Modify Harness When Replacing Rear Door

Classification	Parts and Accessories Bulletin	Section/Group	17 - Electrical	Country/Region	North America, Europe
Year	2012-2014	Model	Model S	Version	All

Figure 1

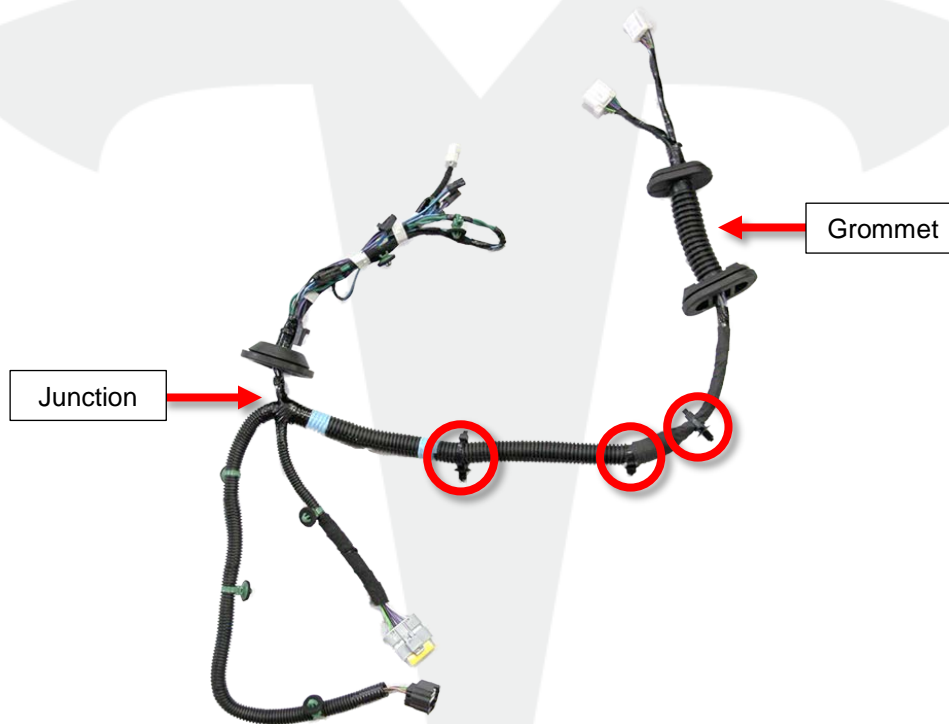
3. Place the harness on a workbench or other suitable working surface.
4. Remove and discard the 3 clips between the grommet and the junction (Figure 1).

Figure 4

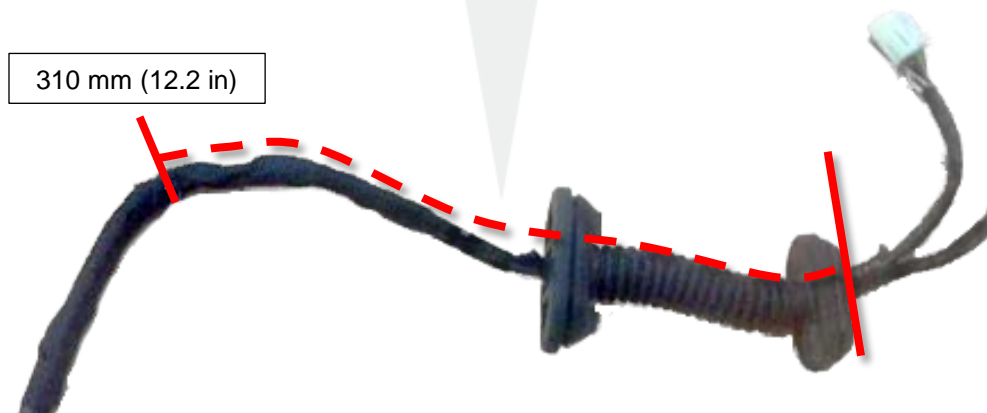
7. Mark the harness 310 mm (12.2 in) from the far edge of the grommet (Figure 4).

Figure 6 (LH rear door shown)

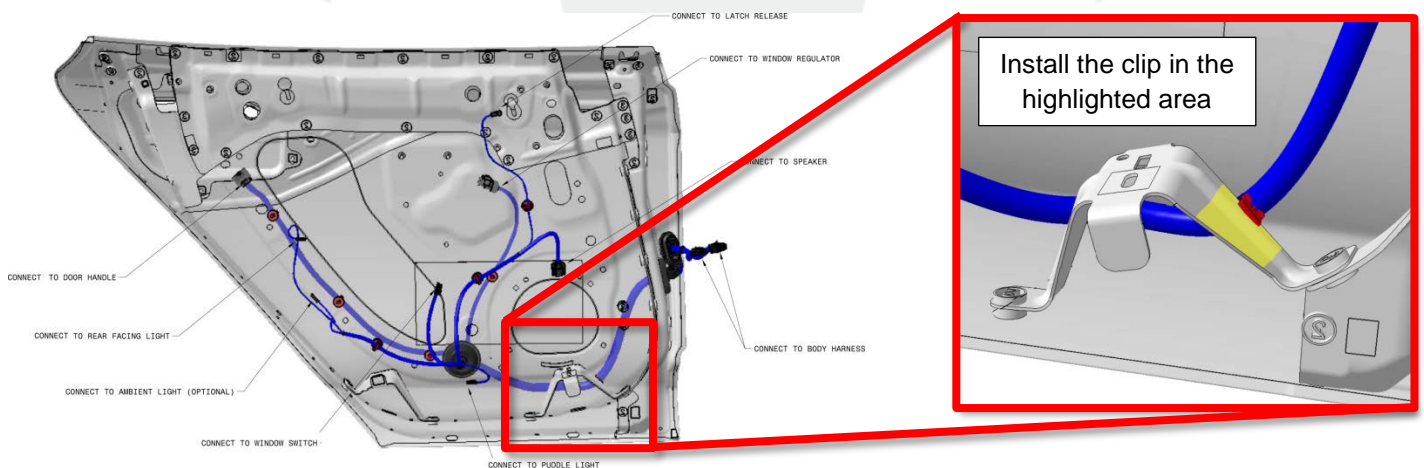
9. When installing the modified harness, attach the new edge clip to the outboard edge of the forward window regulator bracket (Figure 6).

⚠ CAUTION: To prevent damage to the harness, ensure that the edge clip is installed in the highlighted area (Figure 6).
